RE: Inspection conducted on September 24, 2021

AFIN 63-00155

Permit Number 0261-S1-R3

Office of Land Resources Regulated Waste Operations Class 1 Landfill Inspection Form

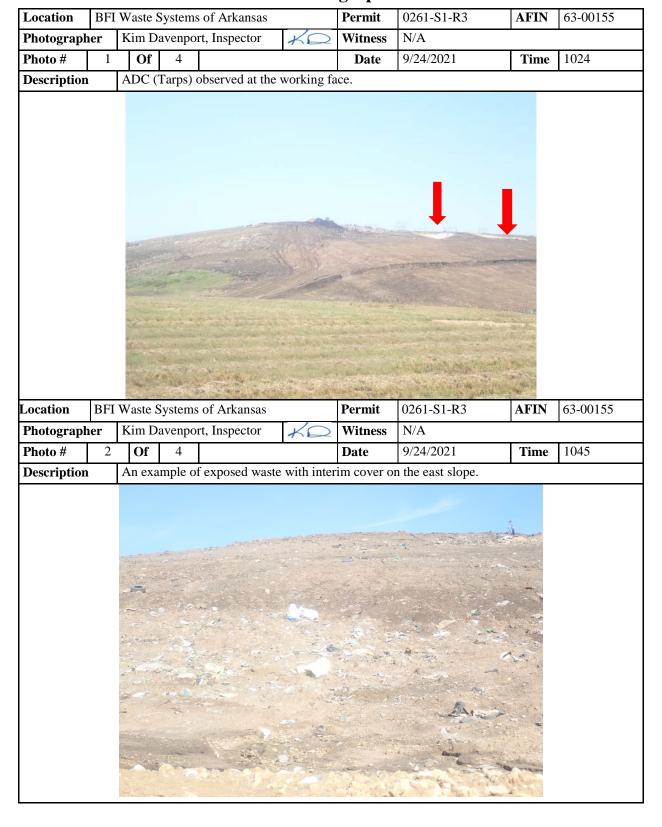
L		Category 2									
		Regulation	Item Description	Comments							
I	X	411(a)	Operations in Accordance with Permit Documents	Tarps were observed at the working face. (Refer to Photo #1.) The alternate daily cover (ADC)							
				demonstration period of six (6) months has expired. (Refer to Doc #78988.) Should BFI wish to							
				continue use of the tarps as an ADC, a demonstration report must be submitted so a determination							
				can be made. (Refer to Documents #71225.)							
		411(c)	Smallest Practical Area, Unloading Supervised, Single Working
